Plan Commission

Agenda

Monday, June 22, 2020

Proposed South Wall Sign with 50 Square Foot Sign Variance (*facing Charles ST*)

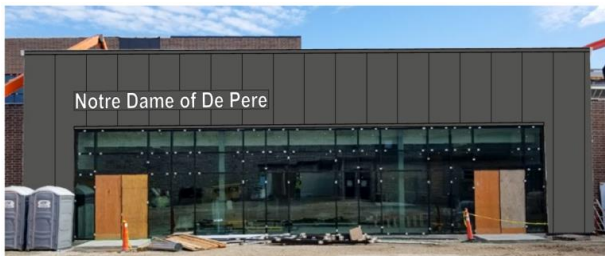
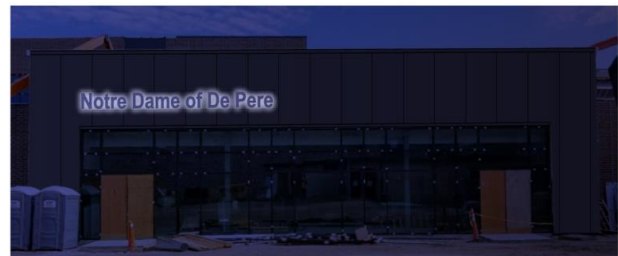
In April, Plan Commission approved a variance for 50 SF halo lit and 80 SF front lit wall signs on the west and east facades of the new Notre Dame School. On June 22, the petitioner is requesting a 50 SF halo lit wall sign on the south façade of the school, rather than a permitted 32 SF wall sign. The petitioner provided supporting documents and graphics related to the request, including a graphic sample of a 50 SF halo lit sign and a graphic sample of a 32 SF internal lit sign (internal lit signs are not permitted, but unlit, halo lit and front lit wall signs are permitted).

NOTE: If approved, based on past meeting public input, the Plan Commission may wish to consider night illumination being placed on a timer that turns off at a specific hour in the evening.

SITE PLAN

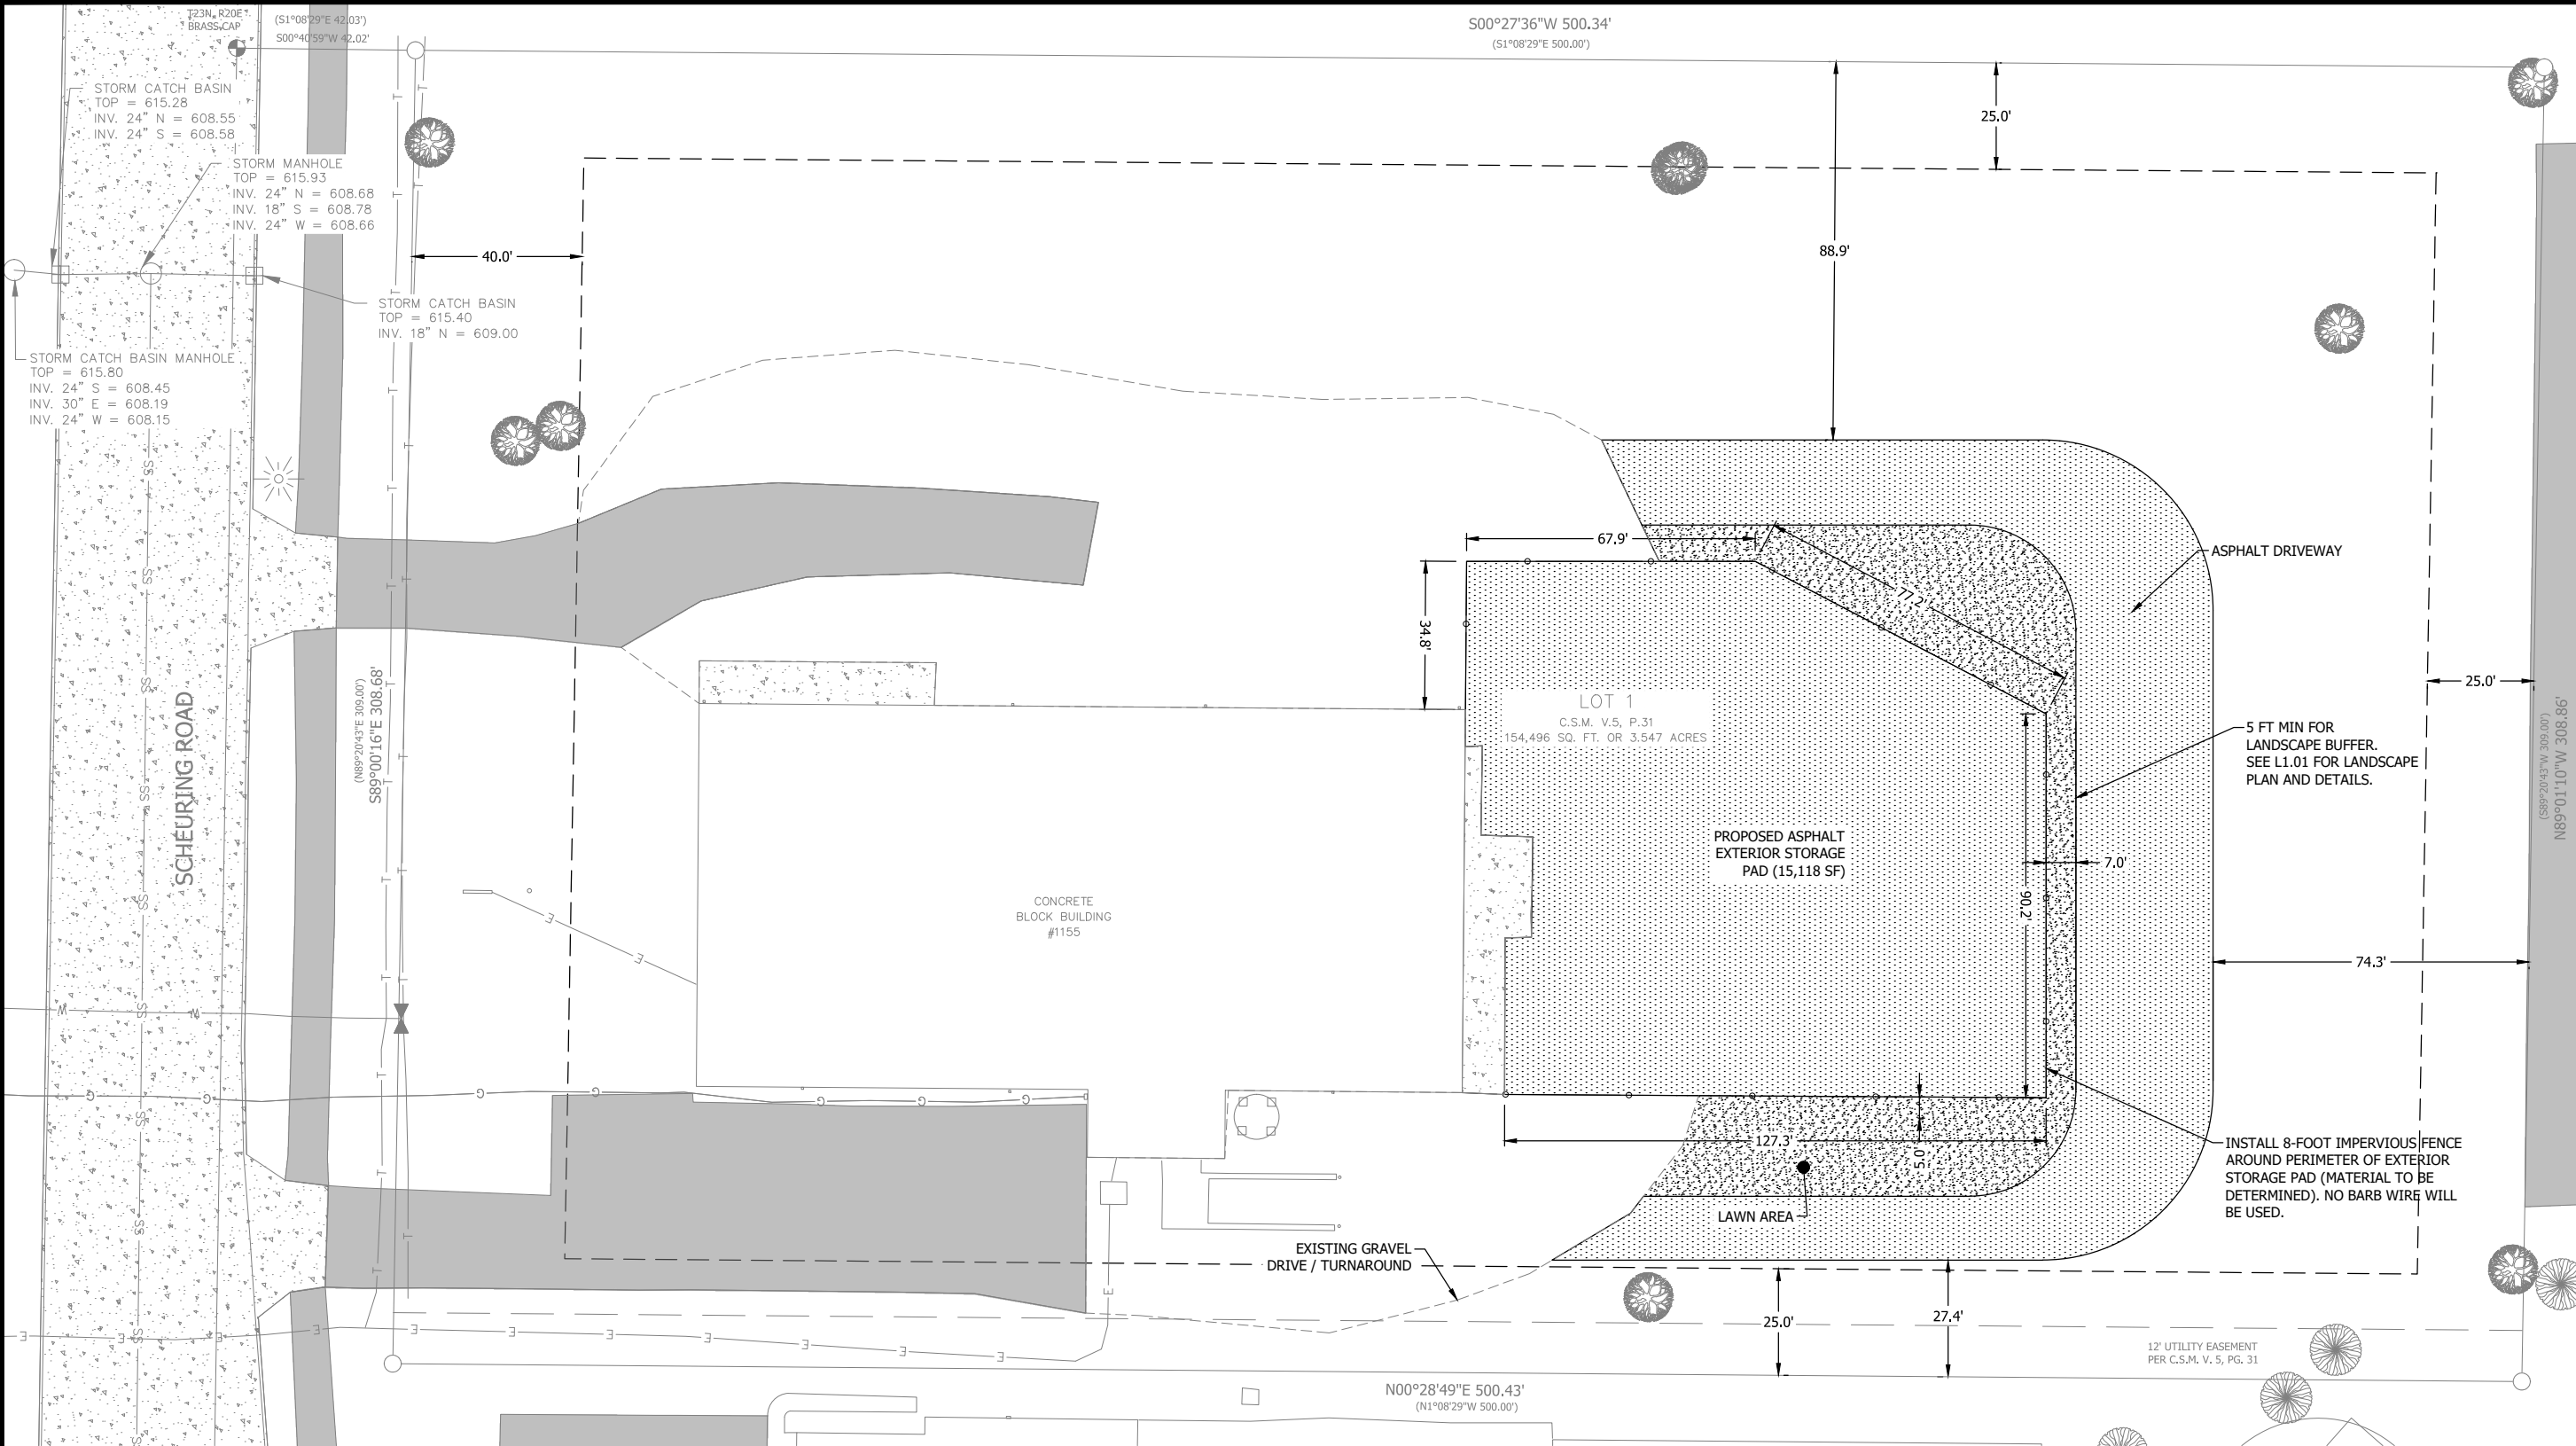
1. Identify the total square footage of the outdoor storage area within the fence on the site plan. Square footage cannot exceed 15,450 square feet.
2. Ensure that the screening fence at the southwest corner of the building connects to the building as the screened area must be 100% impervious without openings.

5. Provide proper dimensions, curve radius, area (square footage) for the added bituminous surface. The site plan only shows general distances from the property lines.

6. Update the Site Calculations data on page C2.01.
7. On page 1, the City of De Pere Planning Contact should read Development Services, not Larry Delo from Planning.

9. Identify the location and number of existing parking stalls. Also identify the required number of parking stalls and verify that the site has sufficient parking ((1 parking space per 2 employees, and 1 space per company truck that is not stored indoors, and space to accommodate visitors).

LANDSCAPE PLAN

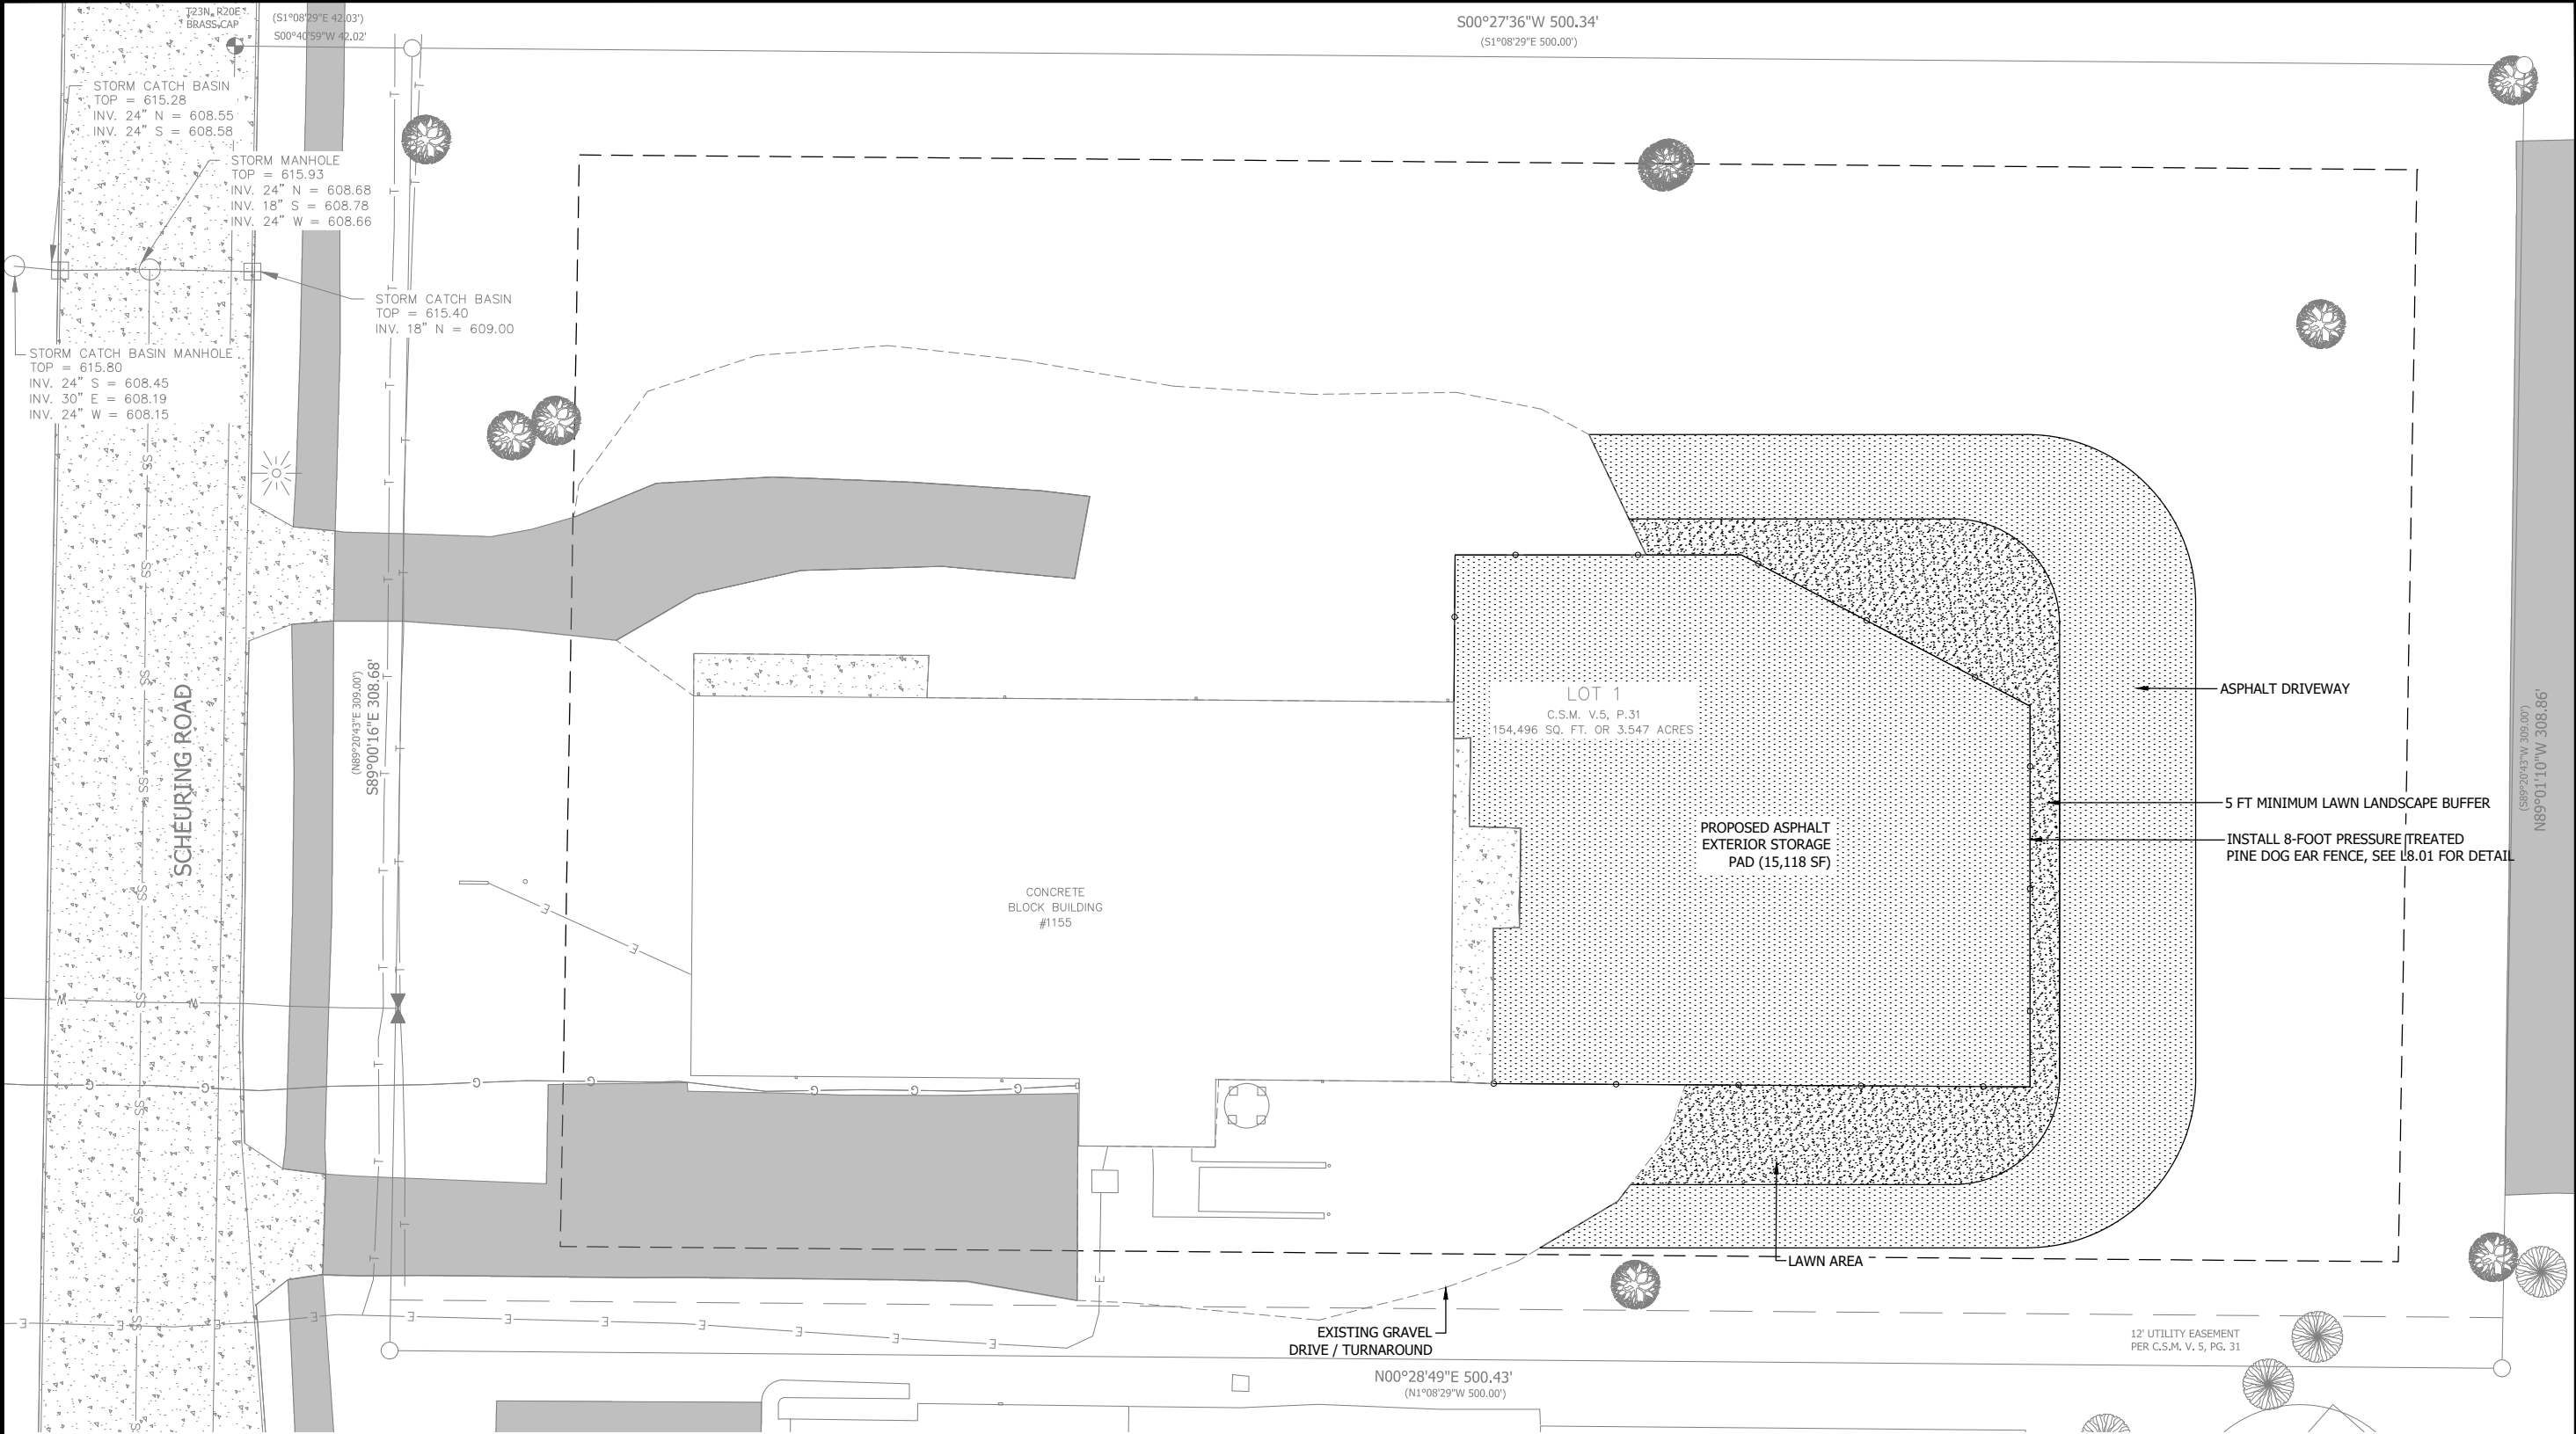
8. To meet the landscaping requirements a total of 16 trees is needed on the site, not 5 as identified on the site plan. Suggest adding trees near the street for street beautification and along the screening fence (spaced 30 feet apart) as identified in the requirements for outdoor storage screening.
